**Economic and Social Council**Distr.: General
20 November 2015

Economic Commission for Europe**Inland Transport Committee****World Forum for Harmonization of Vehicle Regulations****Working Party on Brakes and Running Gear****Eighty-first session**

Tyres – Regulation No. 54**Proposal for amendment to Regulation No. 54 (Tyres for Commercial Vehicles and their Trailers) and Regulation No. 117 (Tyres, Rolling Resistance, Rolling Noise and Wet Grip)****Submitted by the experts from the European Tyre and Rim Technical Organisation***

Paragraph 3.1.10., amend to read:

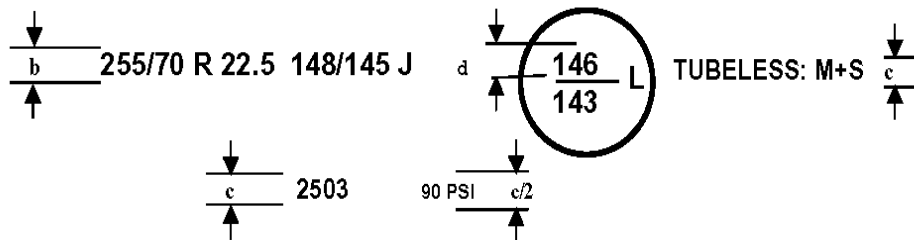
"3.1.10. An indication, by the "PSI" index, of the inflation pressure to be adopted for the load/speed endurance tests, as explained in Annex 7, Appendix 2. However, this indication, which it is permissible to restrict to one sidewall, shall not be mandatory, on any tyre submitted for approval, until two years after the date of entry into force of this Regulation.⁵

For tyres first approved after 1 January 2018, the inflation pressure for the dimension measurement and for the load/speed endurance test, pursuant to paragraph 4.1.12. of this Regulation, shall be indicated in kilopascals, replacing the "PSI" index.

It is allowed to use kPa marking instead of PSI for tyres first type approved before 1 January 2018. "

Annex 3, replace:

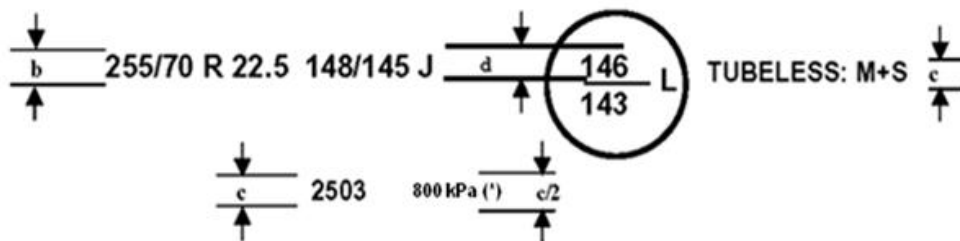
(*) PSI marking instead of kPa is allowed for tyres first type approved before 1 January 2018. "
